STATE OF NORTH CAROLINA
DEPARTMENT OF TRANSPORTATION

Addendum No. 1
RE: Contract # C204039
WBS # 34243.3.2
STATE FUNDED
Polk County (I-4729A)
I-26/US-74/NC-108 Interchange Modifications in the Town Of Columbus

September 19, 2017 Letting

The following revisions have been made to the Roadway plans:

14-AUG-2017 08:20
J:\14729A\Roadway\XSC\I-4729A_Rdy_xpl.dgn
$$$$USERNAME$$$$

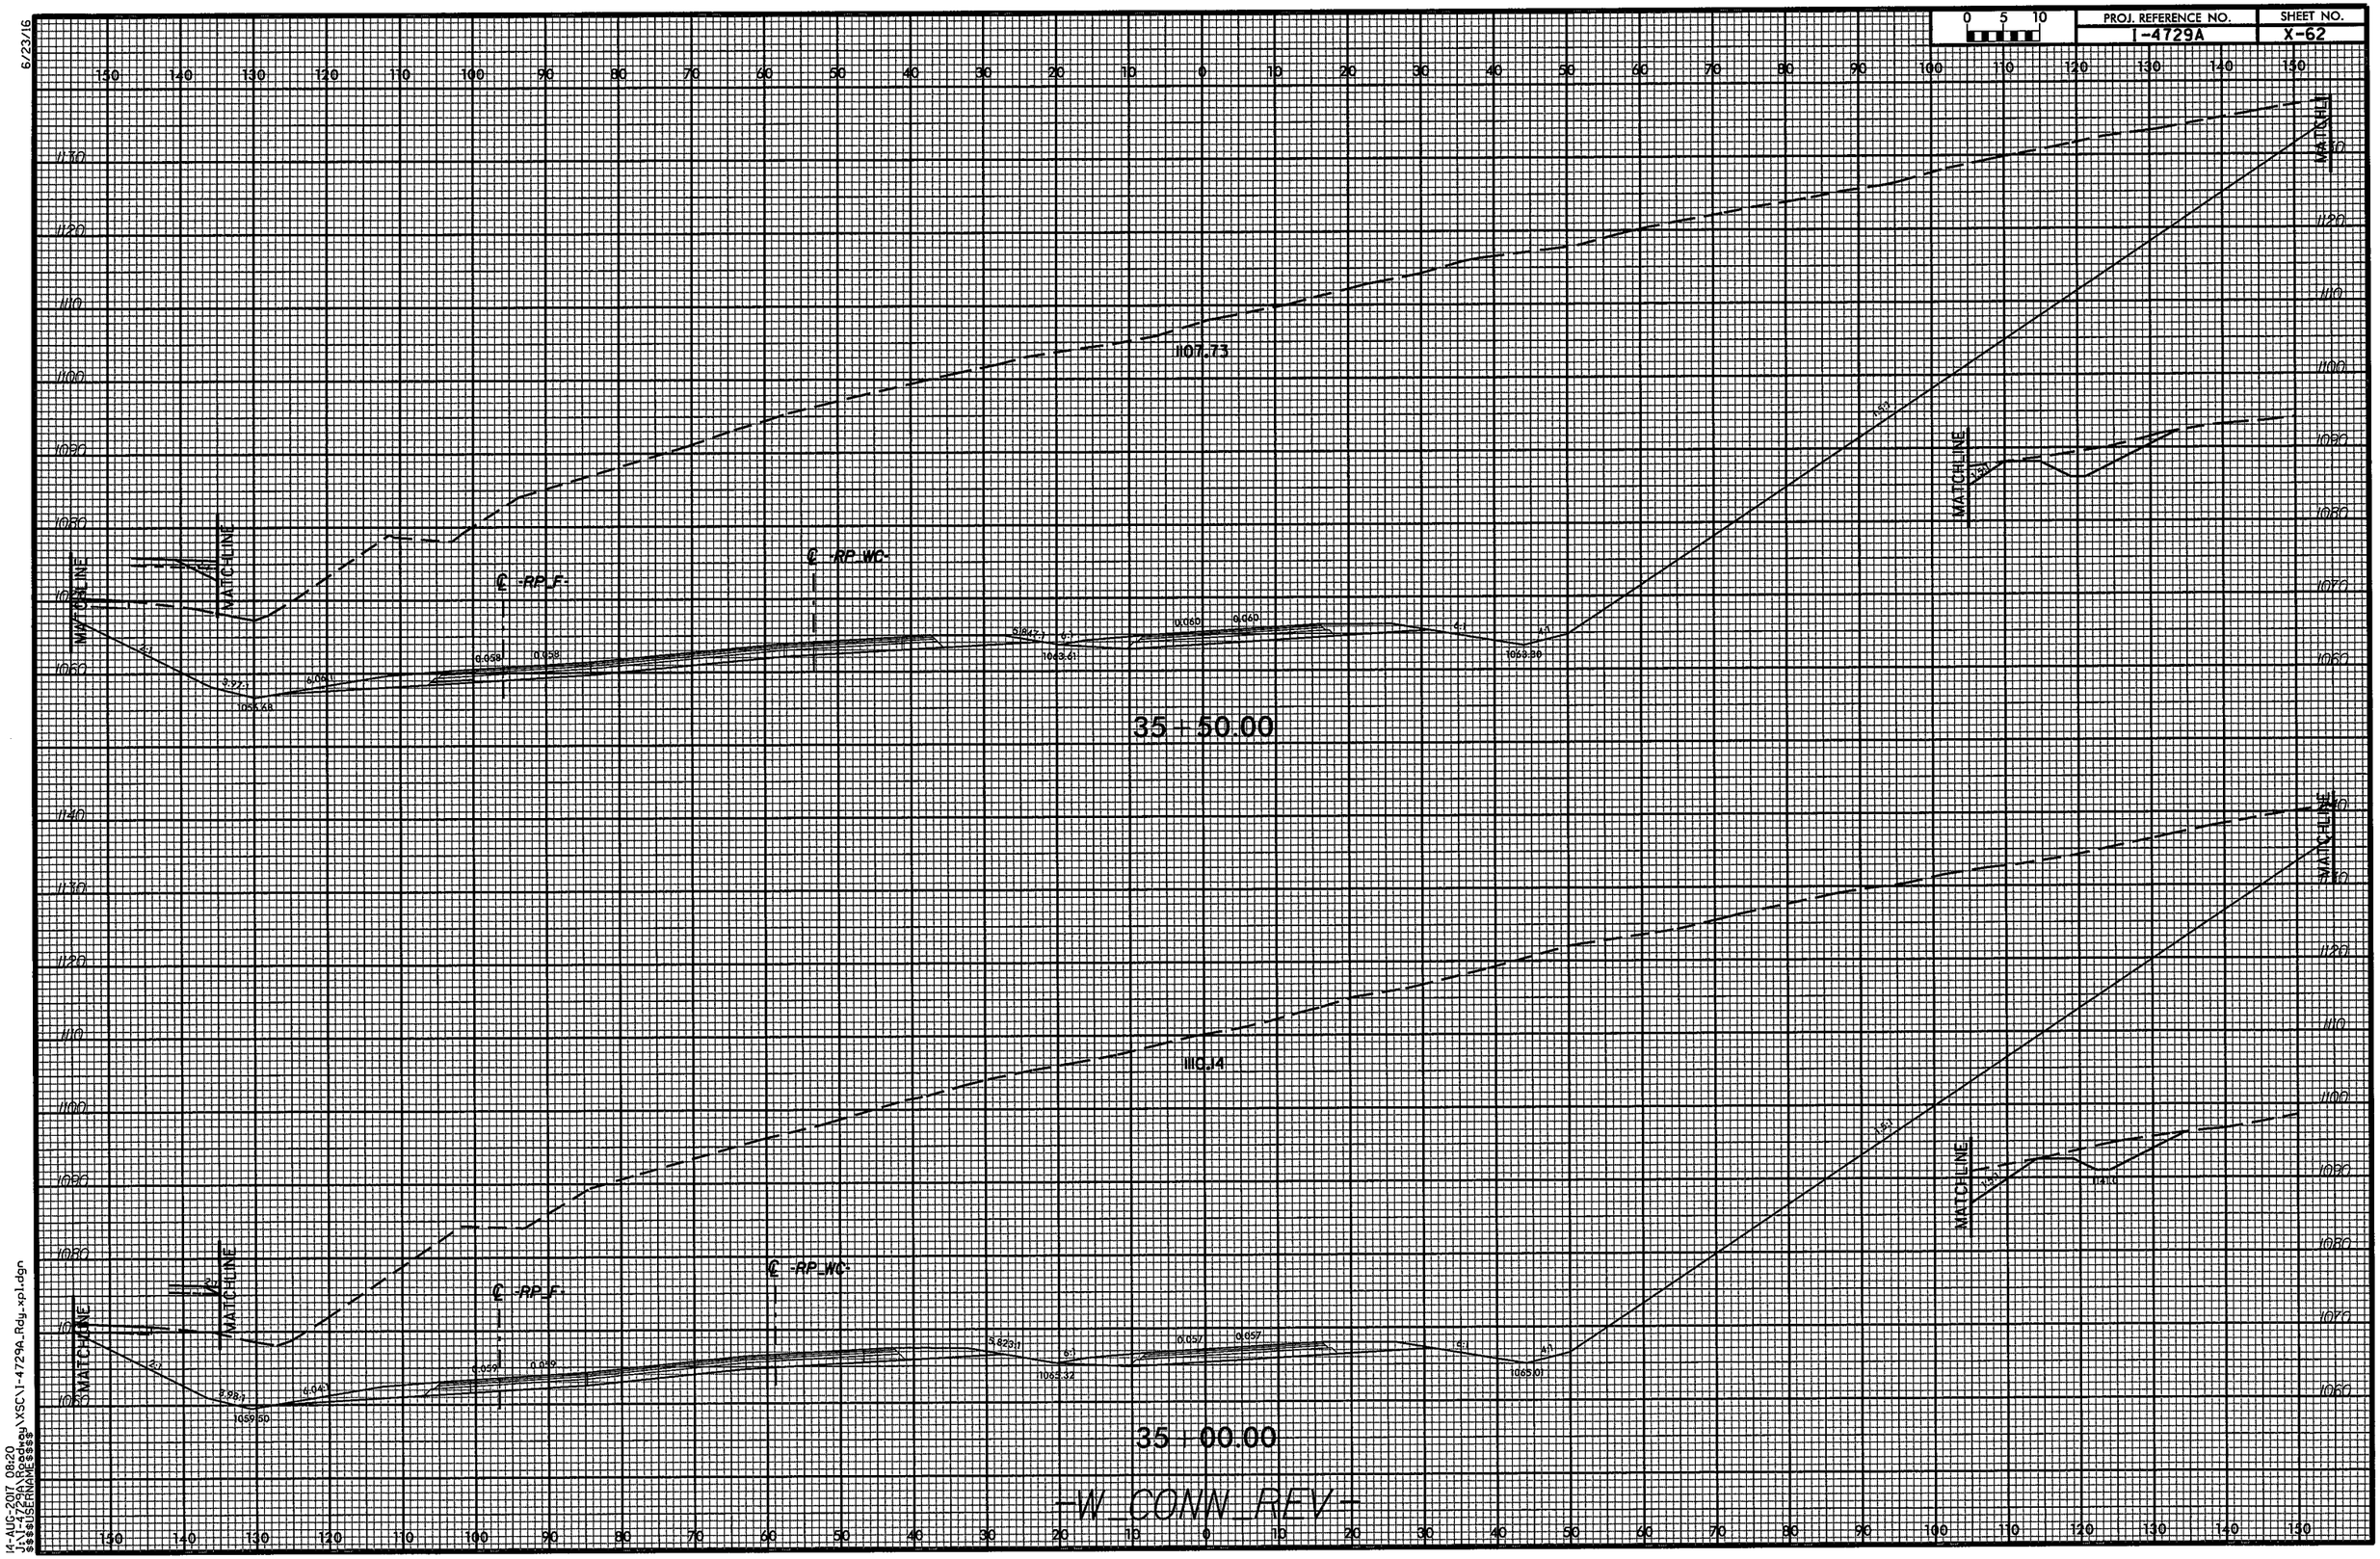
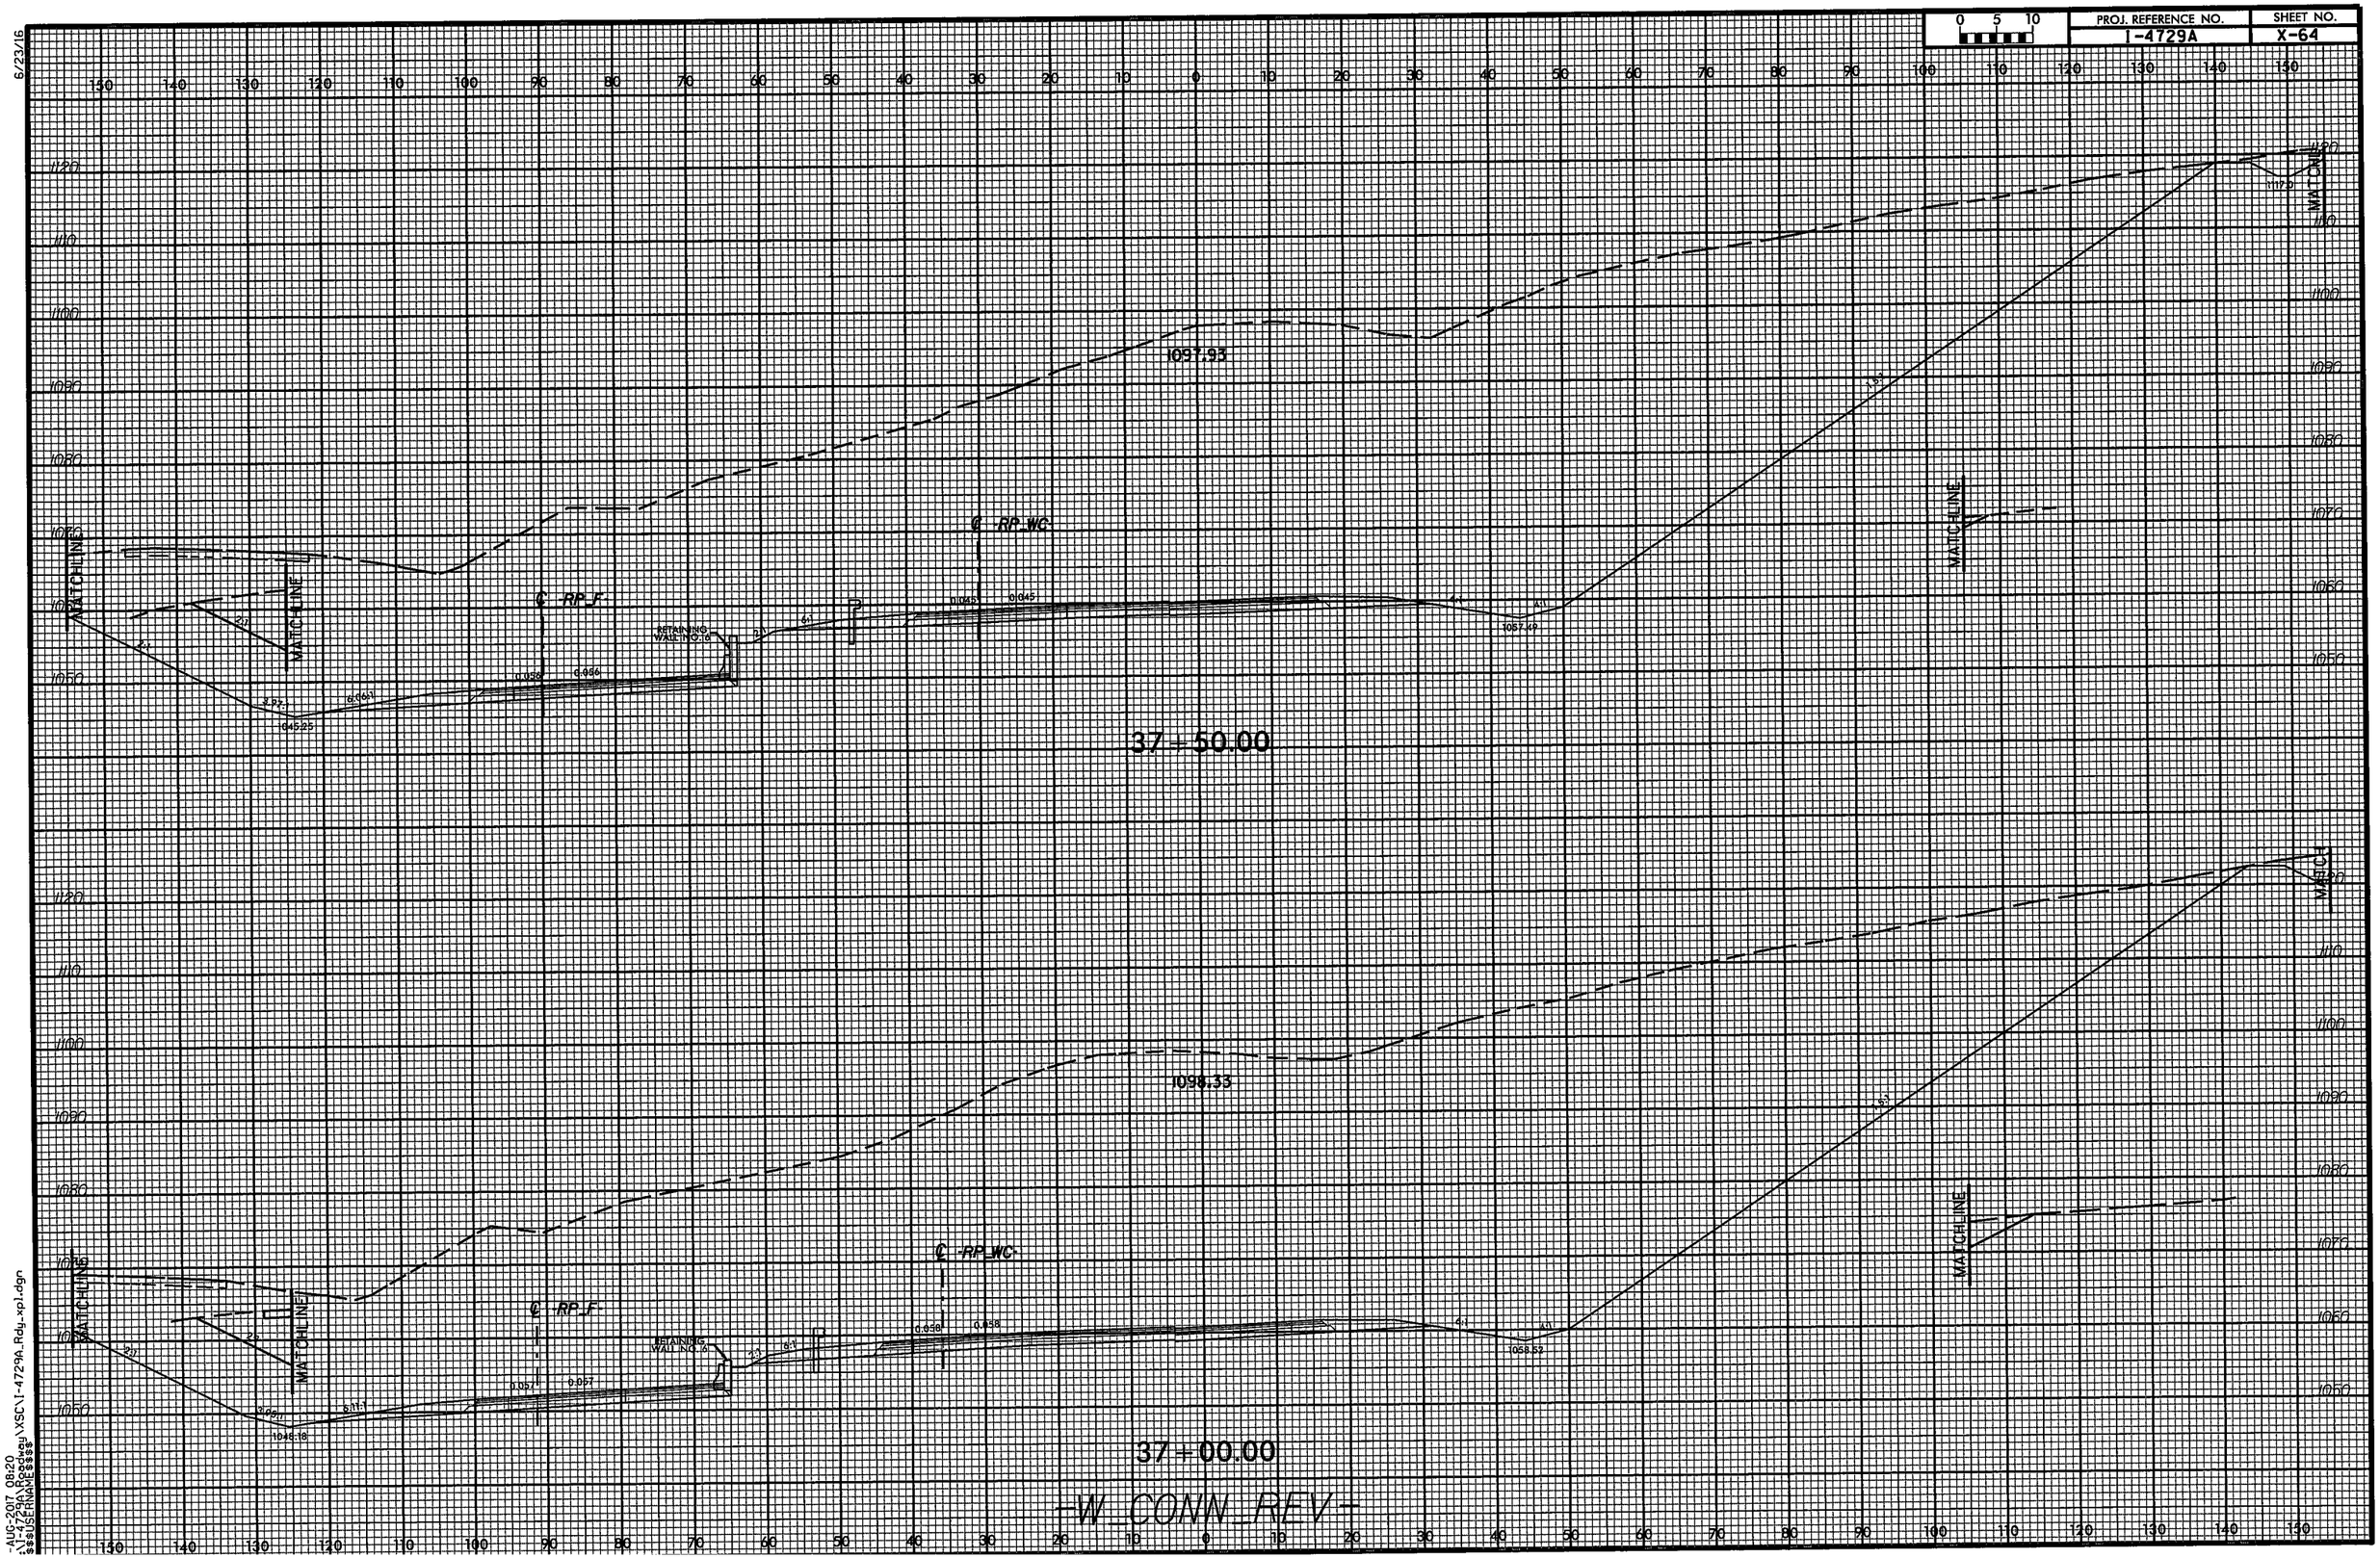
Sheet No.	Revisions
1A	Revised Index of Sheets to remove 2G-2 "Standard Embankment Monitoring Detail" and revise the number of" Drainage Summaries" sheets
2A-1, 2A-4 and 2A-5	Revised the Typical Sections for the change in mainline pavement widening design from ABC to Asphalt Base
3B-1	Revised 'Summary of Earthwork' to account for pavement widening design change
3D-1 thru 3D-4	Various drainage quantity changes as noted below
3G-1	Removed "Settlement Gauge Summary" and added note that Bridge Waiting Period only applies to Approach Slab construction
5	Revised to require Welded Steel Pipe by Trenchless method under the Interstate 26
X-1A thru X-87	Revised Cross-Sections to reflect the change in Earthwork due to the pavement design change
